I. Type of Well  Oil Well  Gas Well  Other  :				8 Well Name and No McDermott #1	, /
2 Name of Operator Element Petroleum Operating, Inc.				9. API Well No 30-025-07075	
3a Address 110 W Louisiana Ave, Suite 405 Midland, TX 79701	/	3b. Phone No (include area co. 918-621-6533	de)	10 Field and Pool or E Sawyer	xploratory Area
4 Location of Well (Footage, Sec., T,	R, M, or Survey Description	on)		11 Country or Parish,	State
1980' FNL & 1980' FWL F Section 30 T-9S-R38E				Lea /

# **ELEMENT PETROLEUM OPERATING** Lease name McDermott Federal Well# #1 Lease NMLC065151

#### Permanent Abandonment of Federal Wells Conditions of Approval

CURRENT CONFIGURATION

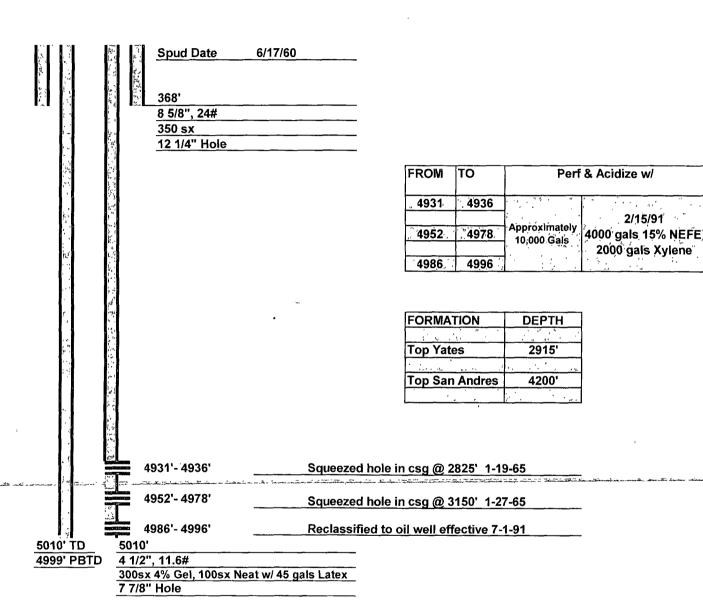
Add plug, perforate esq @ 2980 SQZ 130' from 2980. 2850, was Tag

SEE ATTACHED FOR **CONDITIONS OF APPROVAL**
